Access Compliance Report

Public Rights-of-Way

Intersection ID: N/A	Main Street: PERIMETER_PY	Cross Street: N/A	Location: SW
ADA ID: 023AA9BF14EC	Ramp Type: PerpDiag	Initial Pass/Fail: Pass	Overall Compliance: No
		Severity Score: 5

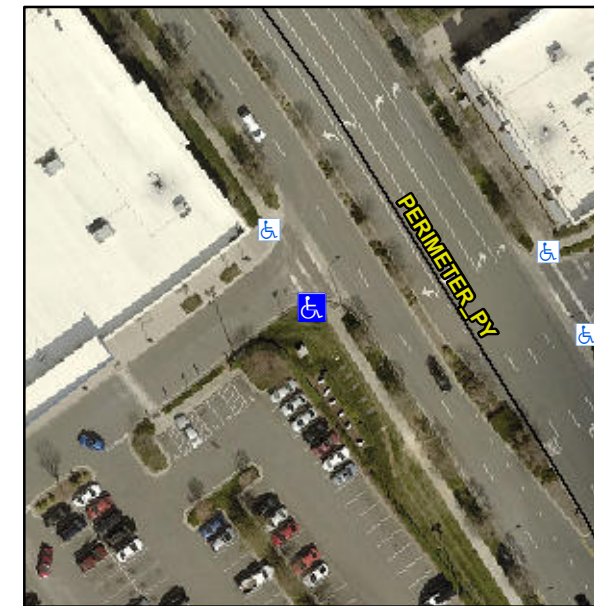
**Remove & Replace Landing.
Remove & Replace Gutter.**

**R304.2.1, R304.2.2-Perp, R304.3.2-
Para, R302.7, R304.5.4**
